HOME2 SUITES FLOWOOD, MS 1ST FLOOR PANELS

- ☒ REVIEWED
☐ REVIEWED AND NOTED
☐ REVISE AND RESUBMIT
☐ REJECTED
☐ RETURNED - SUBMITTAL NOT REQUIRED

1-00 — COVER
 1-01d THRU 1-77d — PANEL DRAWINGS

PANELIZERS, LLC

PNL.#: 1-44e QTY: 2

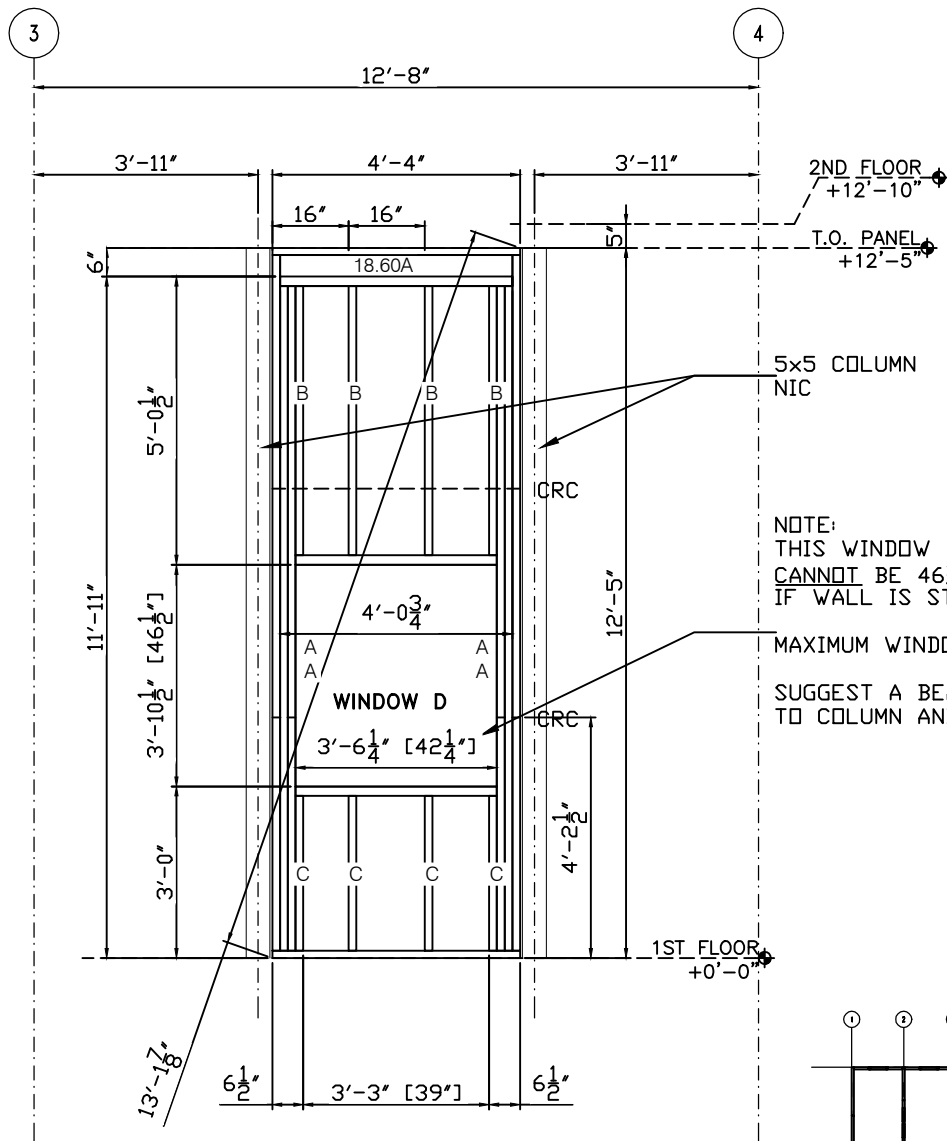
NOTE:
THIS WINDOW
CANNOT BE 46½" WIDE
IF WALL IS STUD FRAMED.
MAXIMUM WINDOW WIDTH SHOWN.
SUGGEST A BEAM FROM COLUMN
TO COLUMN AND INFILL.

PNL.#: 1-51e QTY: 3

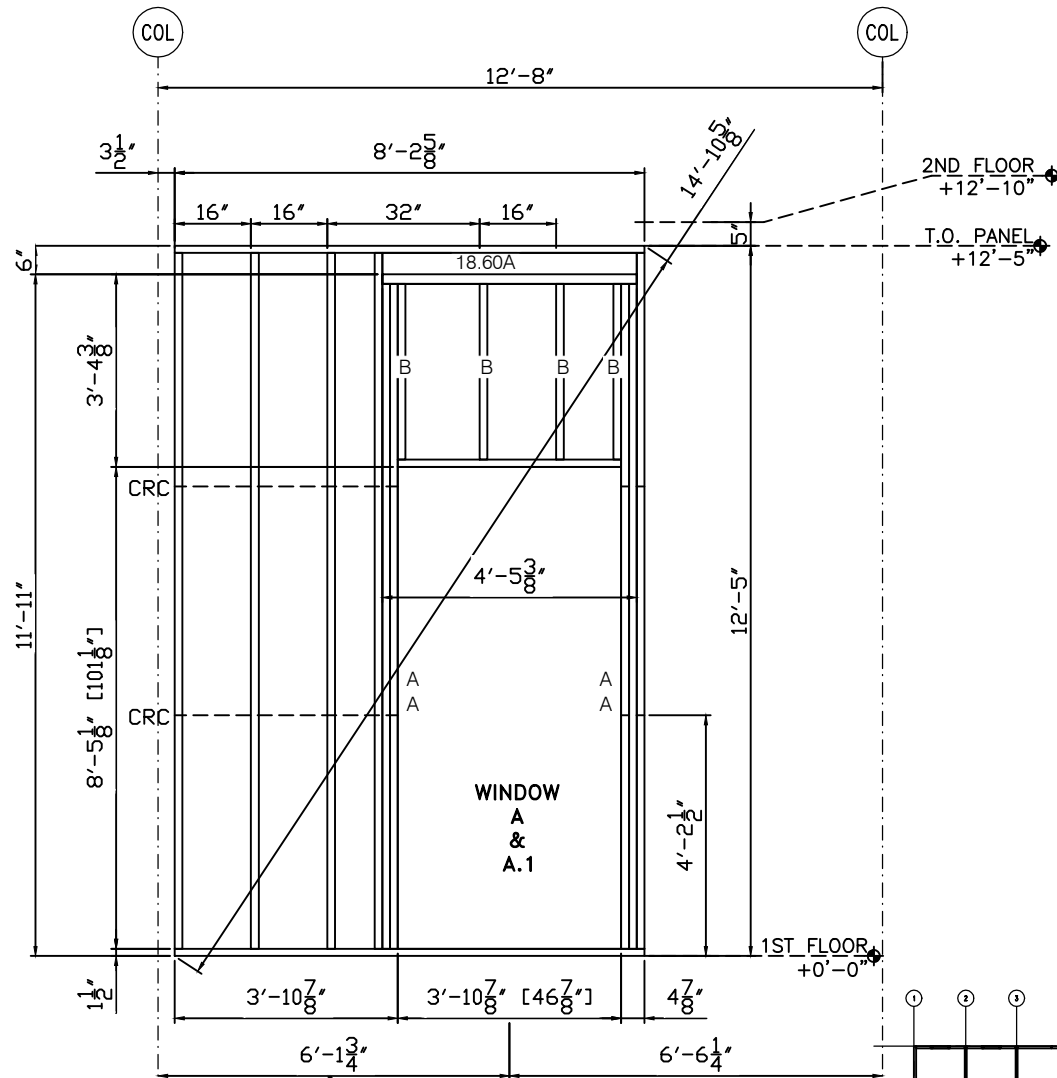
NOTE:
BECAUSE THIS IS ADJACENT
TO A COLUMN, THIS WINDOW
CANNOT CENTER BETWEEN COLUMN LINES.
